## **2.4 Core Cooling Systems**

The information in this section of the reference ABWR DCD, including all subsections, tables, and figures, is incorporated by reference with the following departures.

Figure 2.4.1a Residual Heat Removal System (RHR-A)

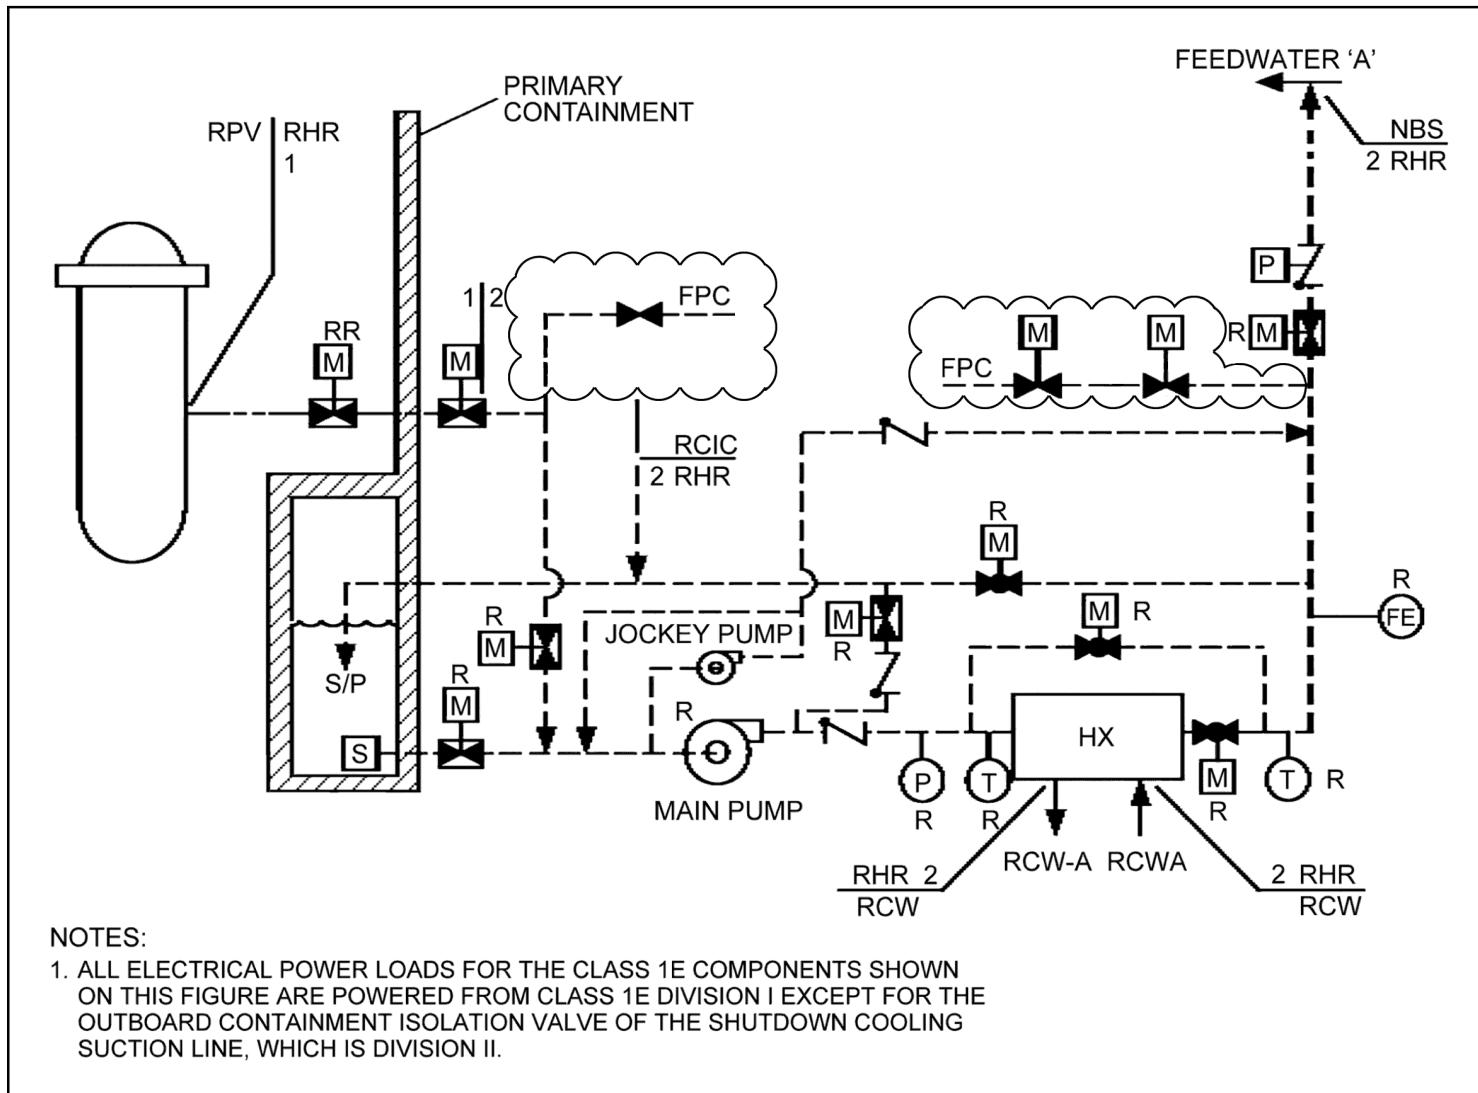
STD DEP T1 2.4-1 (Figure 2.4.1a, Table 2.4.1)

~~the shutdown cooling suction line, titled "From FPC."~~ For RHR A and B, the upgraded branch lines from the main pump suction include the path to and including the suppression pool suction valve, the path to the shutdown cooling outboard containment isolation valve, the path to the jockey pump's discharge valve including the jockey pump's bypass line and the path to the (and including the valve) the Fuel Pool Cooling System that branches off the shutdown cooling suction, titled, "From FPC." For RHR-C, the upgraded branch lines include all the paths listed for RHR-A and B plus the pipeline and valves that are part of the AC independent water addition mode that extends from the noncode boundary indicated by "NNS" to the "external connection" outside the "reactor building" and to the Fire Protection System interface indicated by "FP."

**Figure 2.4.1b Residual Heat Removal System (RHR-B)**

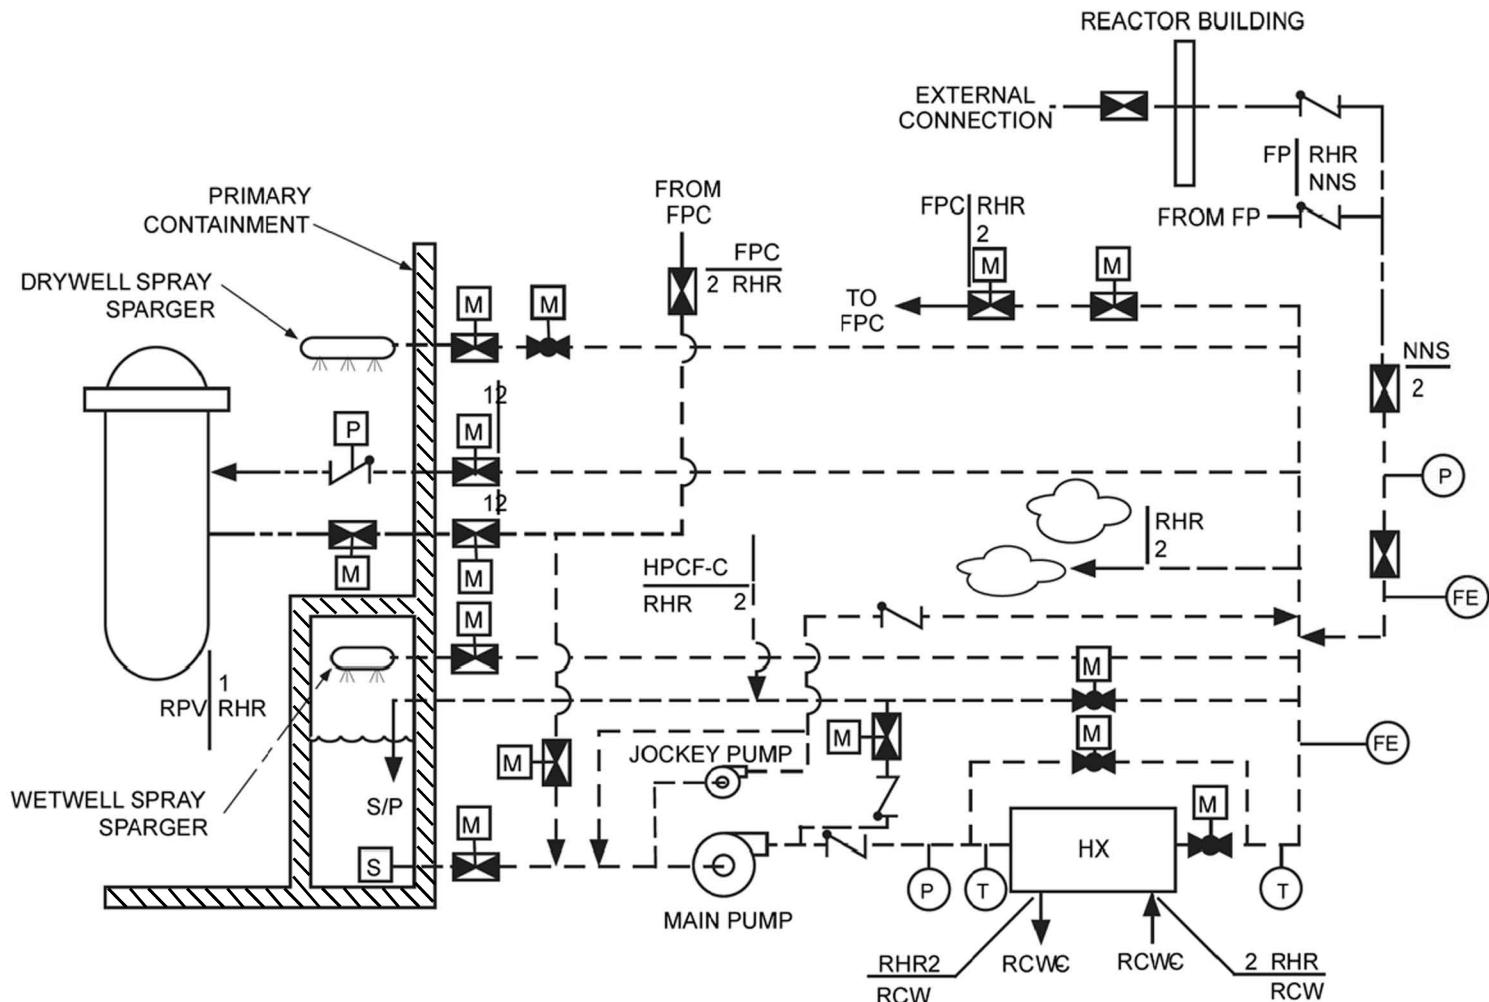
STD DEP T1 2.14-1 (Figure 2.4.1b, Figure 2.4.1c, Figure 2.4.3)

Figure 2.4.2 Leak Detection and Isolation System Interface Diagram

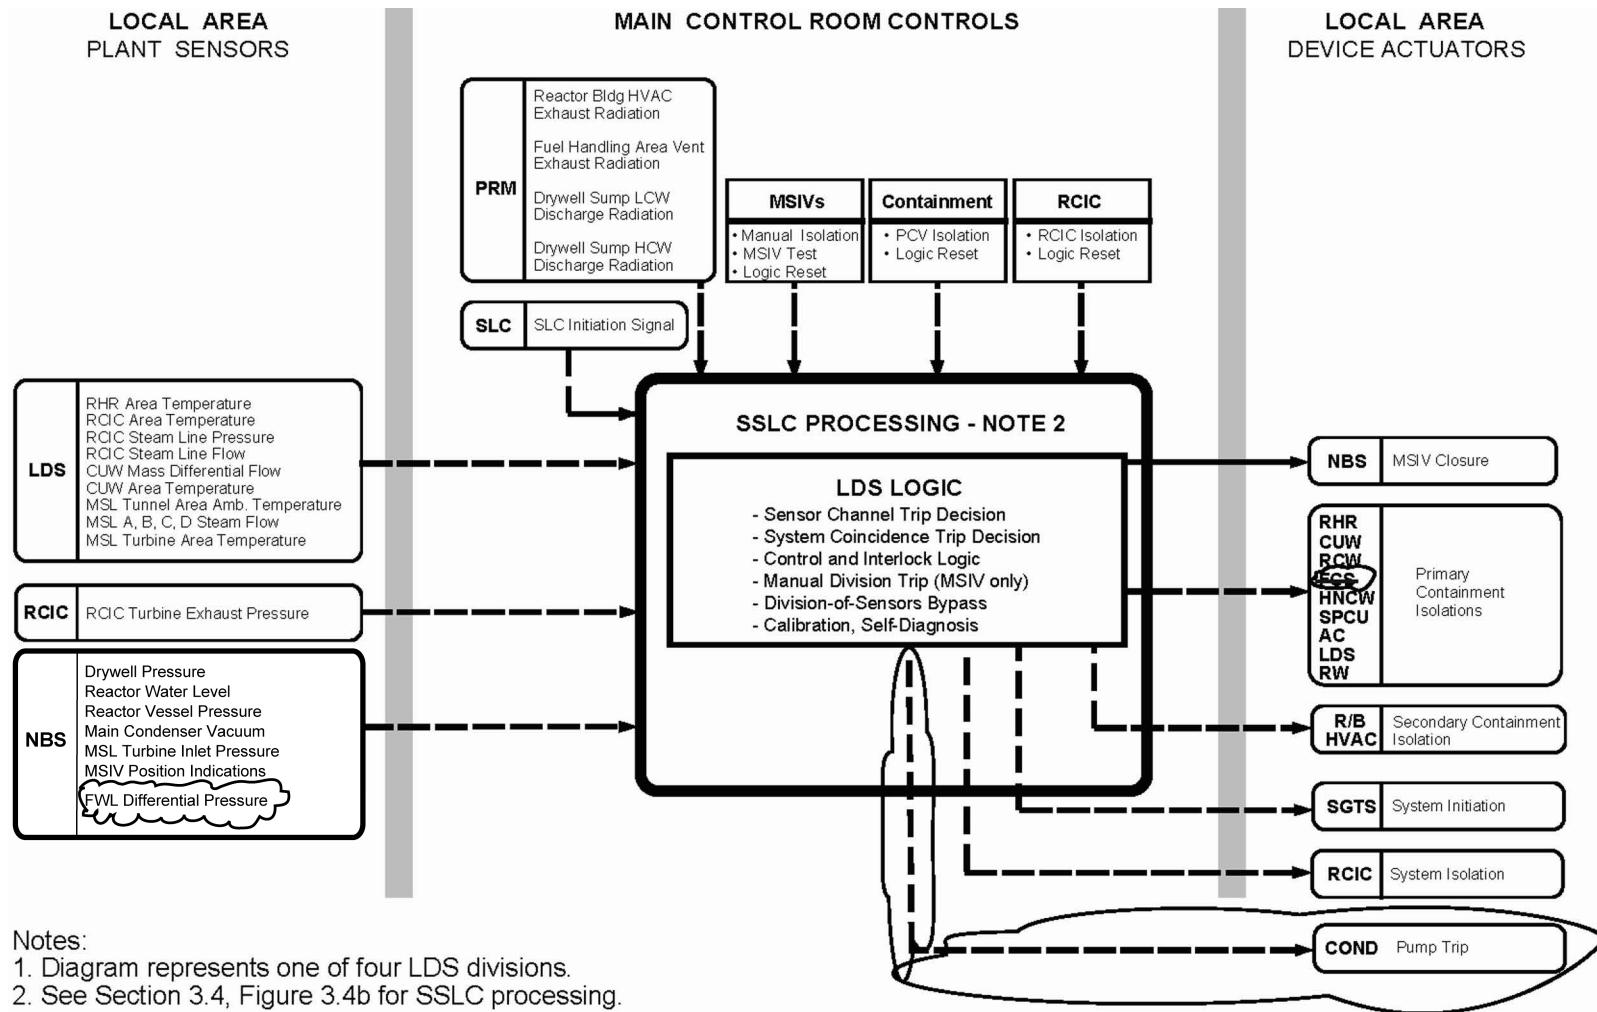
STD DEP T1 2.4-2 (Leak Detection System) Figure 2.4.3

STD DEP T1 2.14-1 (FCS, Figure 2.4.3)

- (9) *Isolation of the Suppression Pool Cleanup (SPCU) System on a signal indicating high drywell pressure or low reactor water level.*
- (10) ~~*Isolation of the Flammability Control System (FCS) on a signal indicating high drywell pressure or low reactor water level.*~~

- (10) ~~*(11) Isolation of the drywell sump low conductivity waste (LCW) and high conductivity waste (HCW) discharge lines on a signal indicating high drywell pressure or low reactor water level. Also, each discharge line is individually isolated on a signal indicating high radioactivity in the discharged liquid waste; only one channel is used for this function.*~~

- (11) ~~*(12) Isolation of the LDS fission products monitor drywell sample and return lines on a signal indicating high drywell pressure or low reactor water level.*~~

- (12) ~~*(13) The LDS provides to the neutron monitoring system a signal indicating a high drywell pressure or low reactor water level.*~~
- (13) *The LDS provides a trip of the condensate pumps on signals that indicate high drywell pressure and high differential pressure between the feedwater lines.*

Figure 2.4.4a Reactor Core Isolation Cooling System

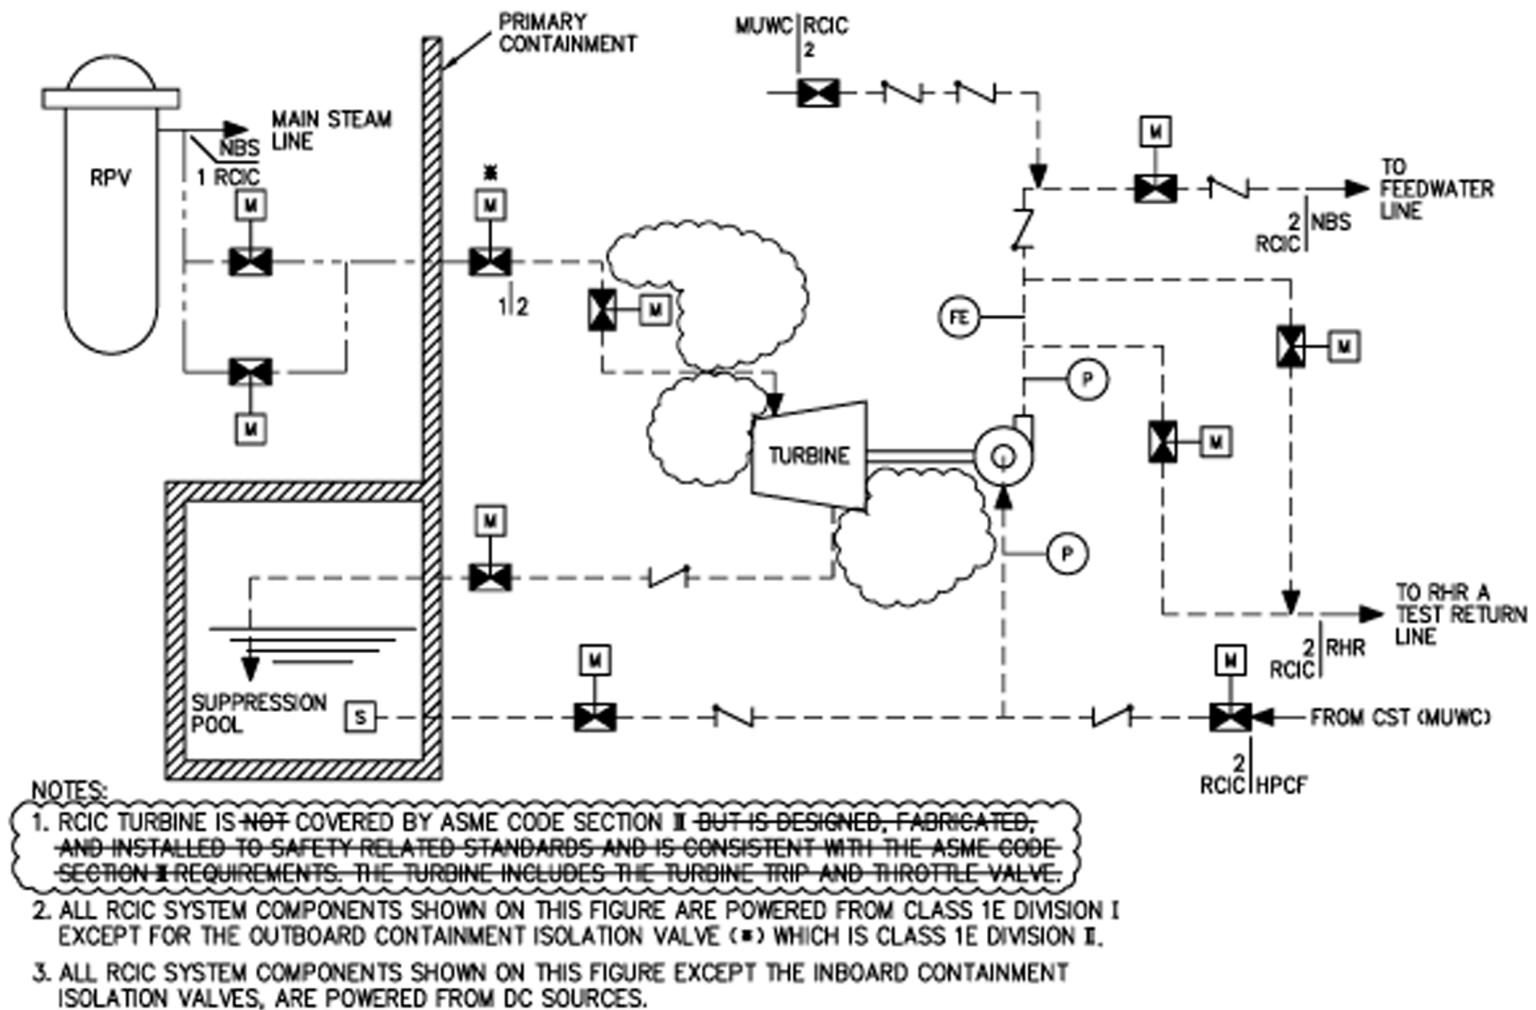
STD DEP T1 2.4-3 (Figure 2.4.4a, Table 2.4.4.)

STD DEP T1 2.4-3
